Responses to Comments

This appendix to the Final Environmental Impact Report (EIR) for the Eddie Jones Warehouse, Manufacturing & Distribution Facility Project (project) includes a copy of all comment letters that were submitted regarding the Draft EIR (DEIR), along with responses to comments in accordance with California Environmental Quality Act (CEQA) Guidelines Section 15088. The 64-day review period for the DEIR began on October 26, 2023, and ended on December 29, 2023.¹

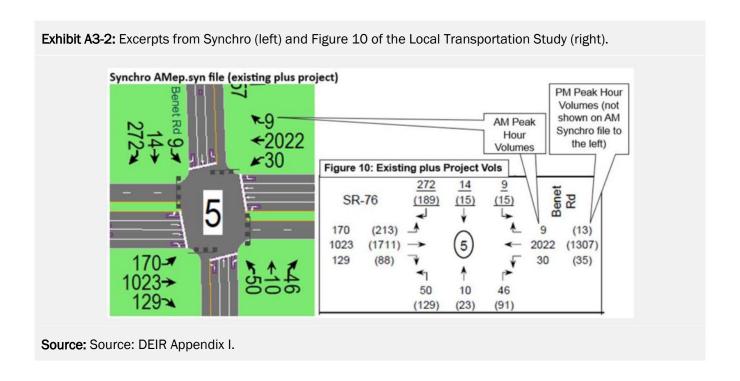
A3-3 The comment states that the AM Existing Plus Project Synchro file does not match Figure 10, Existing plus Project Volumes, of the Local Transportation Study for the SR-76 and Foussat Road intersection,

the SR-76 and I-5 southbound ramps intersection, and the SR-76 and I-5 northbound ramps intersection. The commenter is mistaken. The orientation of the two figures referenced in the comment is different, but the peak volume counts are the same. To illustrate that point, excerpts from the AM existing plus project Synchro file match excerpts from Figure 10, as shown below in Exhibit A3-2.

Exhibit A3-3: Synchro output worksheet from DEIR Appendix I (p. 86) (top) and Synchro screenshot (bottom).

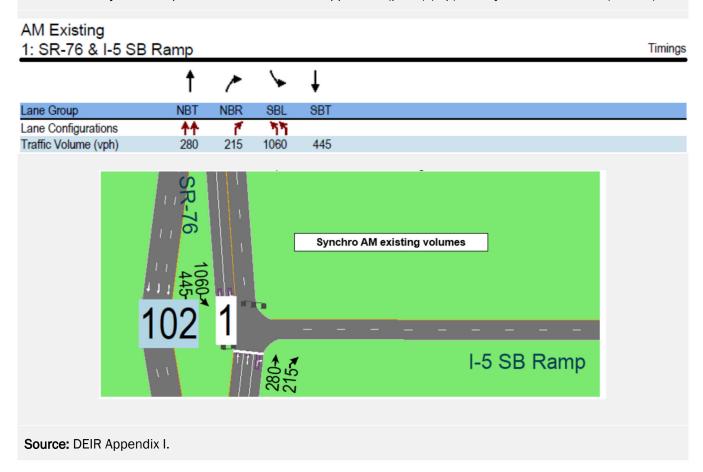
A3-4 The comment states that the AM existing Synchro file shows a volume of 0 for the southbound to SR-76 eastbound movement. Please see Response to Comment A3-2 explaining how intersection #1 has a clockwise clover leaf ramp from I-5 southbound travel to SR-76 eastbound travel and does not permit vehicles to pass through this traffic signal because the clover leaf ramp connects to SR-76 approximately 140 feet northeast of intersection #1. The AM existing Synchro output and screenshot correctly show a volume of 1,060 AM trips on the southbound left turn onto the I-5 southbound ramp; this is documented in the Synchro output included in the LTS (DEIR Appendix I, p. 86) (Exhibit A3-3).

Figure 4

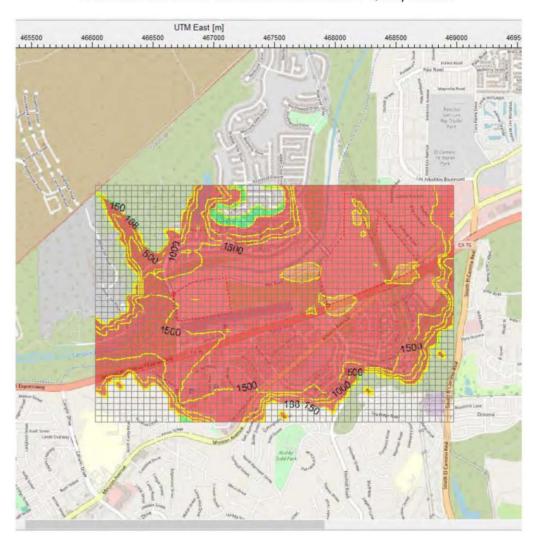
Areas Inside the Contour Labelled 188 exceeds the Air Quality Standard

Figure 5

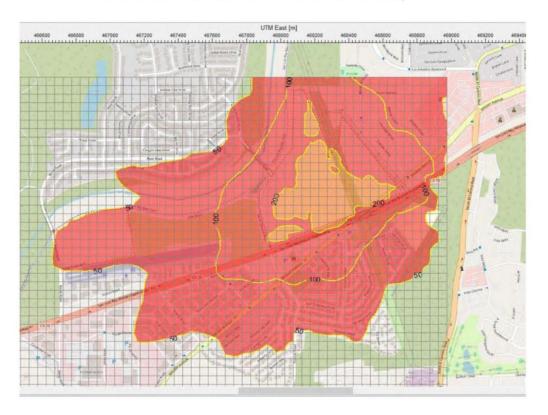
Areas Inside the Contour Labelled 50 exceeds the Air Quality Standard

Figure 6

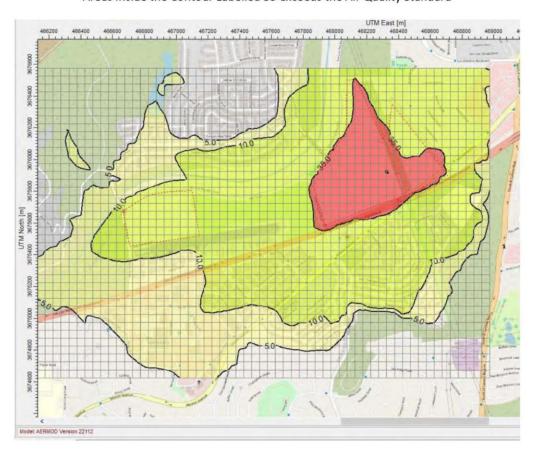
Areas Inside the Contour Labelled 35 exceeds the Air Quality Standard
